**PRELIMINARY CONCEPT
ALTERNATIVE 2B
JUNE 20, 2014**

THIS ALTERNATIVE HAS BEEN REMOVED FROM CONSIDERATION

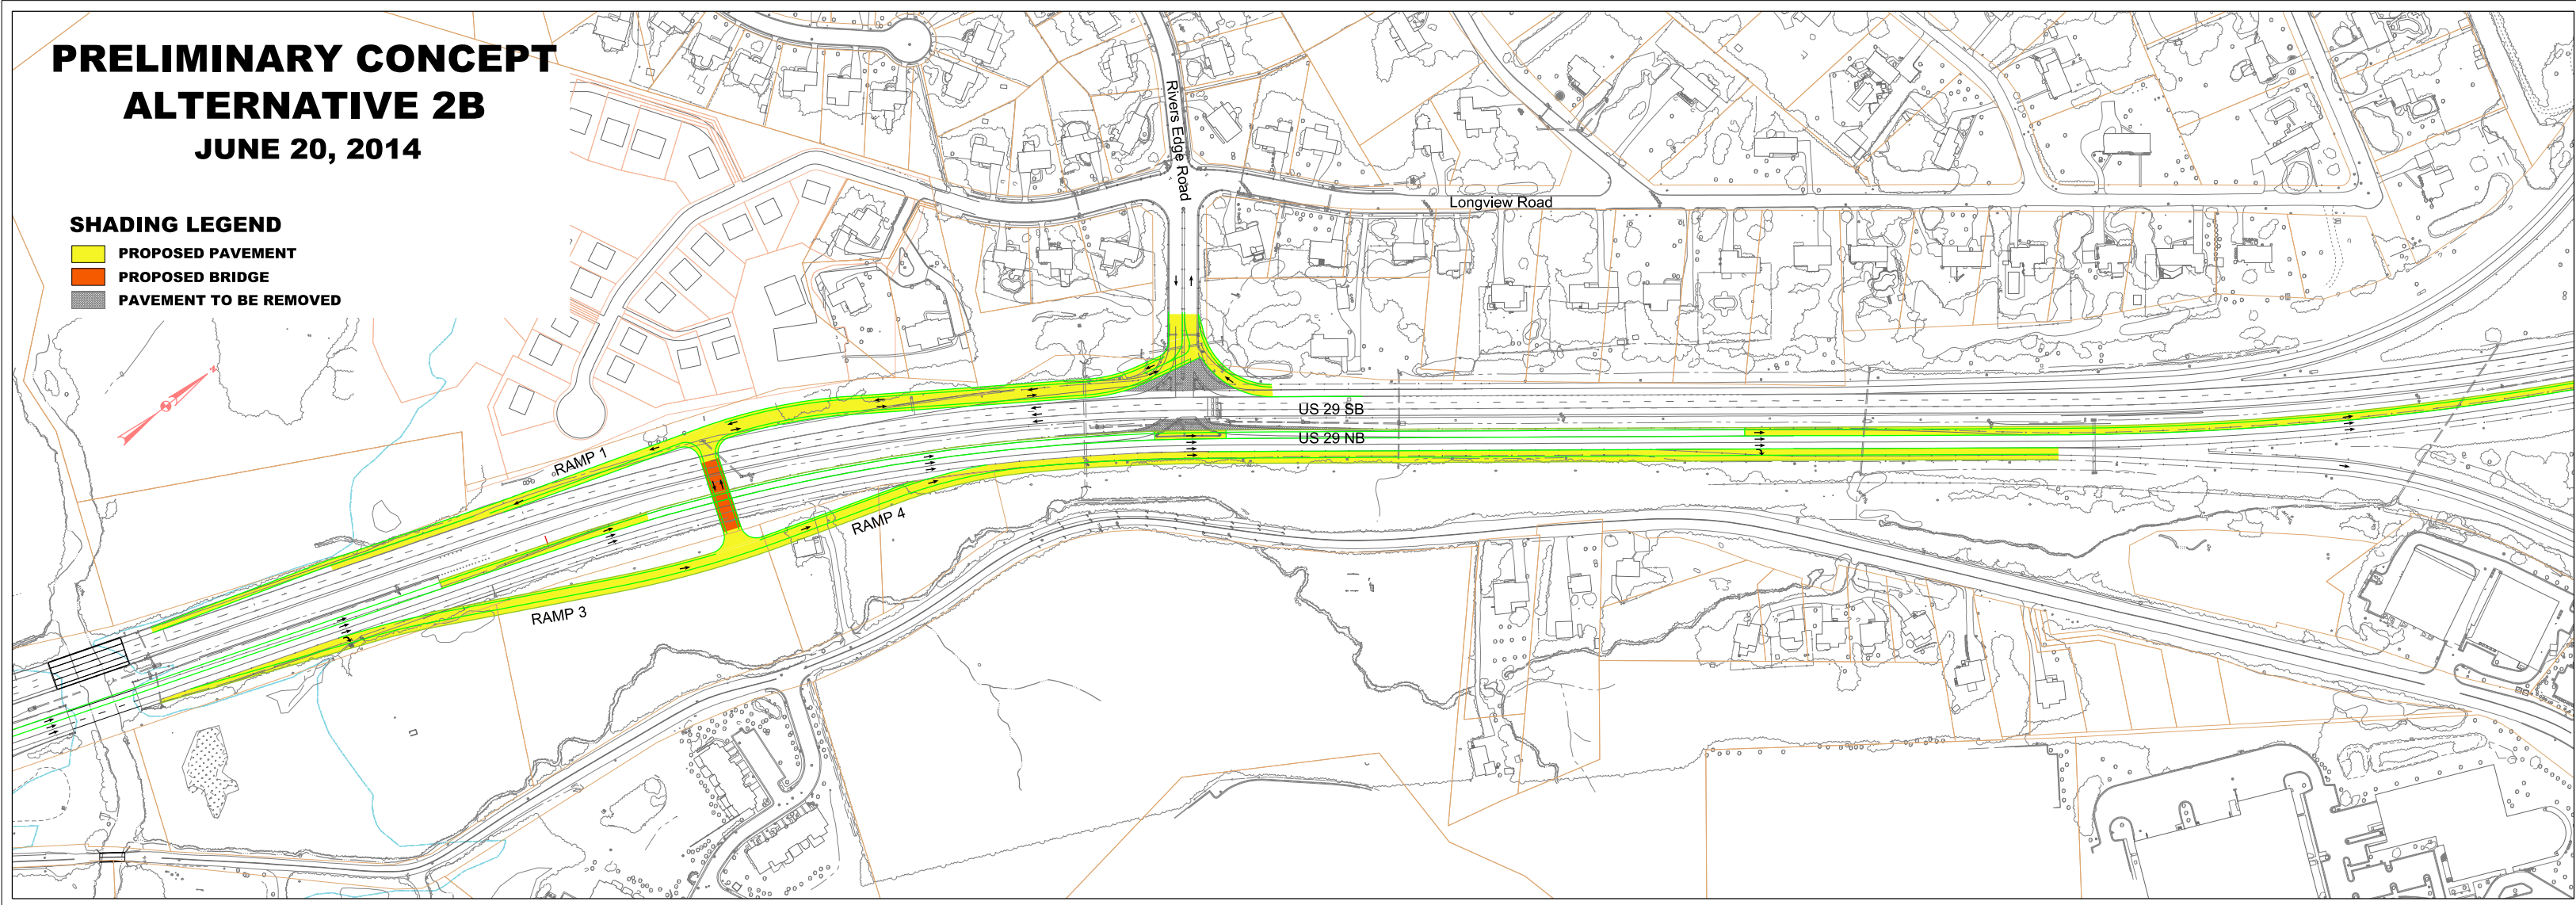
- 10% slopes on Ramps 1 and 3 are required between existing US 29 and overpass grades. To bring the slopes within acceptable ranges (8% max.) would require decreasing acceleration and deceleration lanes for Ramps 1 and 3 below acceptable lengths, or shifting overpass further north, which would worsen weaving condition between Ramp 4 and eastbound US 32 ramp to below acceptable distance.
